Better UW for the 802.11 FH PHY Preamble

Naftali Chayat, LANNAIR
Tel-Aviv, ISRAEL

Fig 1: Correlation of the ..5555 09AF preamble with the 09AF template

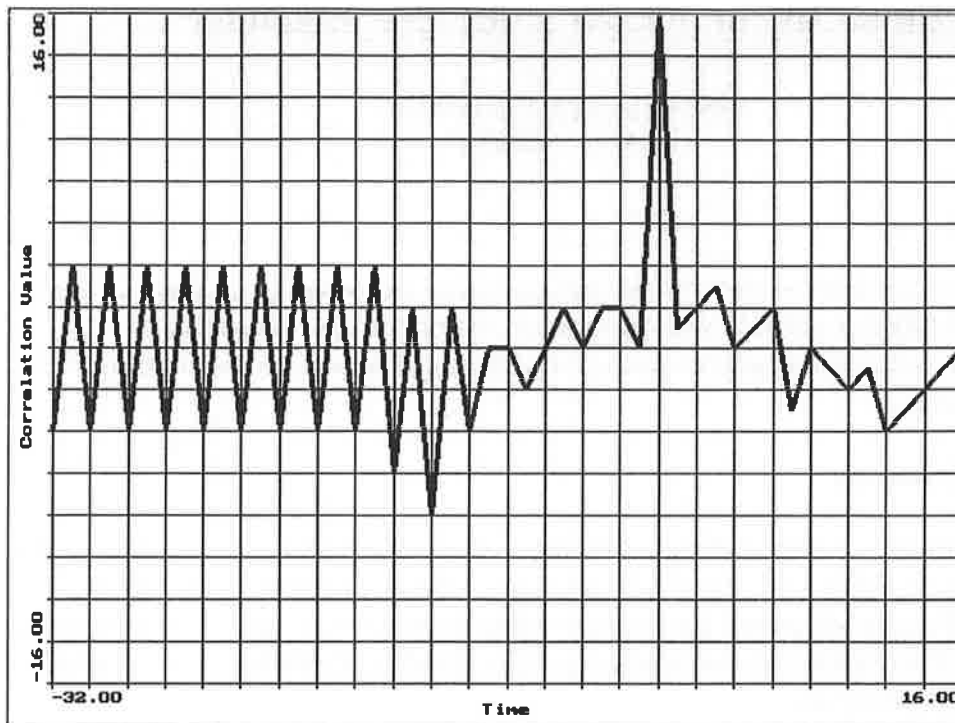
Current contribution compares the preambles by looking at the correlation of the **..5555 XYZT** preamble with the **XYZT** template. We propose to consider the sequence with lower maximal correlation value over the $[-\infty .. -1]$ interval as a better one. The maximum correlation is 4 for **09AF** and **3785** (fig. 1,2), while it is just 2 for **0CBD** (fig 3).

We move to adopt ..5555 0CBD as the preamble for the FH PHY.

Fig 3: Correlation of the .5555 OCBD preamble with the OCBD template

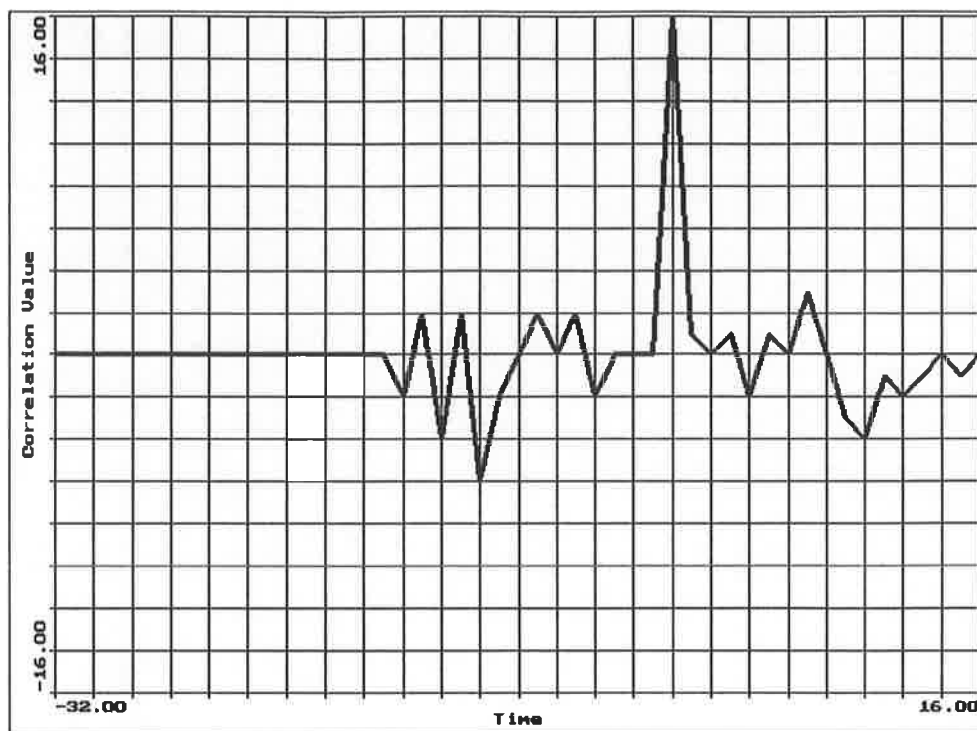
The meaning of this advantage is that for about same false alarm probability during the idle the detection threshold can be lowered by 2 (less one agreement), for example a detection threshold of 12 instead of 14 can be used (14 instead of 15 agreements). At BER of 10^{-2} the probability of nondetection is 0.012 in the case of 12 and just 0.00056 in the case of threshold 14. For better BER the difference is even more pronounced. For example, at BER of $1e-3$ the nondetection probabilities are $1.2e-4$ and $5.6e-7$.
